MODIFICATION APPLICATION

[NEW FAIRING COVERS ADDITIONAL 1 1/2" OF TOP SURFACE OF FLAP]

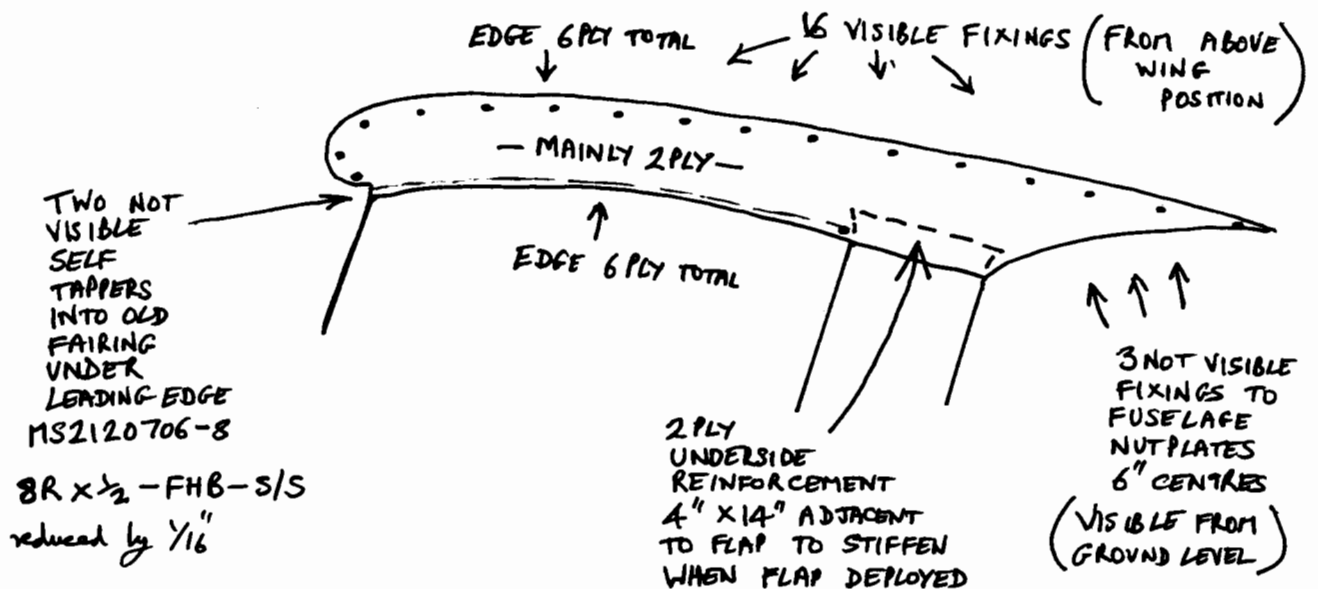
6mm PVC FOAM HEAT FORMED ON JIG TO SHAPE

CURVATURE RADIUS (APPROX 7/8" APART)

- 4" -
- 4" -
- 4" -
- 5" -
- 6" -
- 7" -
- 8" -
- 8" - T.E.
- 8" -
- 8" -
- 8" -

WING TOP SKIN

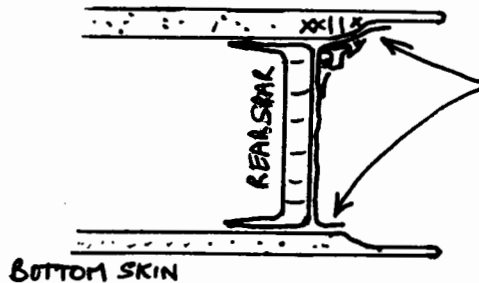
2PLY TAPE 2" x 4 1/2" UNDER NUTPLATE
NUTPLATE N^{OS} SECURED WITH FLOX
AND 2" x 1" TAPE ON TOP

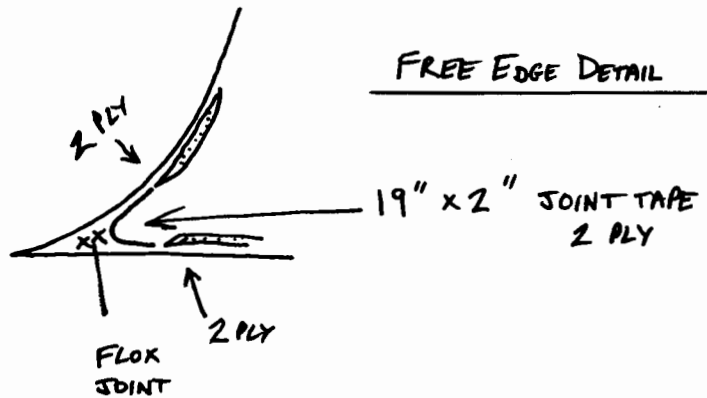
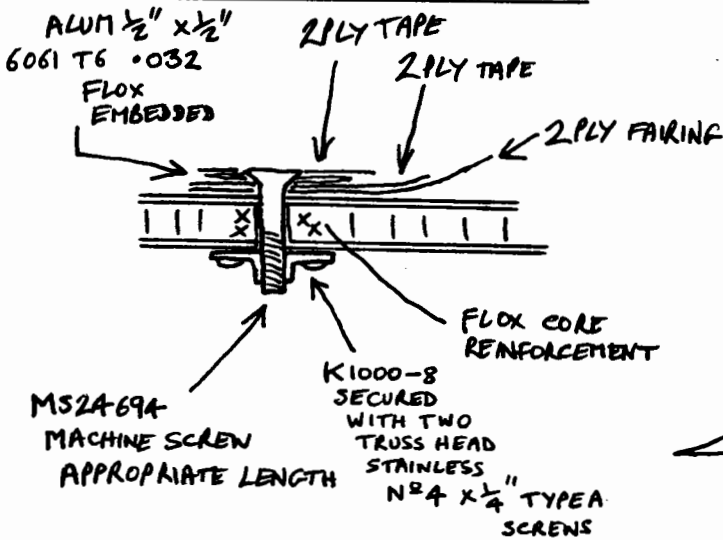
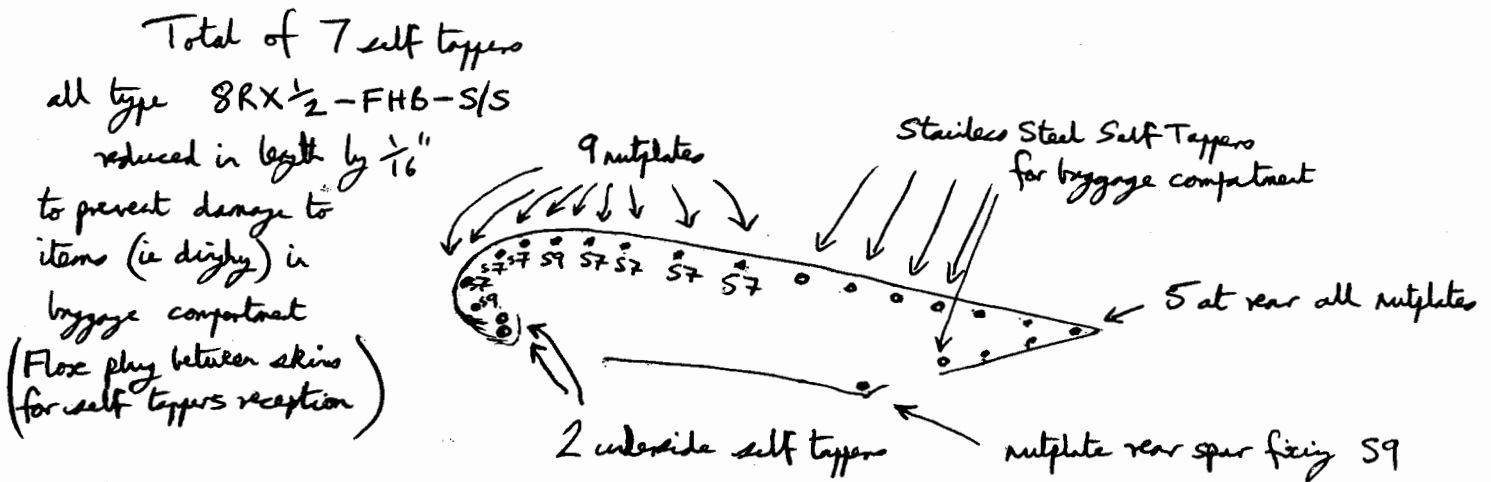
ALL FIXINGS EXCEPT WHERE NOTED AS FOLLOWS :

FIXINGS MS24694-S9 MACHINE SCREWS & S7 & BR x 1/2 - FH6-S/S REDUCED BY 1/16"
NUTPLATES K1000-8

FABRIC USED S GLASS STYLE 4533 - 5.8 OZ. Sq. yd. P/N: 4533-60 SPRUCE USA.
SURFACE FINISHED FILLED MICRO, LIGHTWEIGHT FILLER etc.

EPOXY RESIN LAMINATING TYPE 285 - PRF COMPOSITE MATLS. POOLE, DORSET
FUSELAGE HOLES REINFORCED ON INNER SKIN WITH 1" SQUARES 2PLY BID
UNDER NUTPLATES WHERE NO OTHER REINFORCEMENT PRESENT.

FABRIC USED FOR HOLE REINFORCEMENT ON FUSELAGE
SPRUCE P/N RA7725 (Sglass NOT USED HERE).

Completed fairings including filler and paint both same weight at 2lb 7oz each
(prior to fill and paint wt of 2lb nil oz average.)

Total of 22 fixings (one extra underside RHS on make up piece to old fairing as below old fairing.)

Per side: 15 machine screws (~~one longer than rest required on RHS least on fuselage longer due to thickness of old fairing here~~)

Initial placement of MS24694-S9 ~~was~~ altered to MS24694-S7 for majority

Done 12.5.02, mainly S7 in cockpit except for two each side S9
(most fwd S9 a bit long on LHS and a bit short on RHS)

Fuselage holes reinforced on inside under nutplates with 1" squares of 2 ply
B/D Spruce P/N RA7725 (Sglass not used here), where no other reinforcement present.
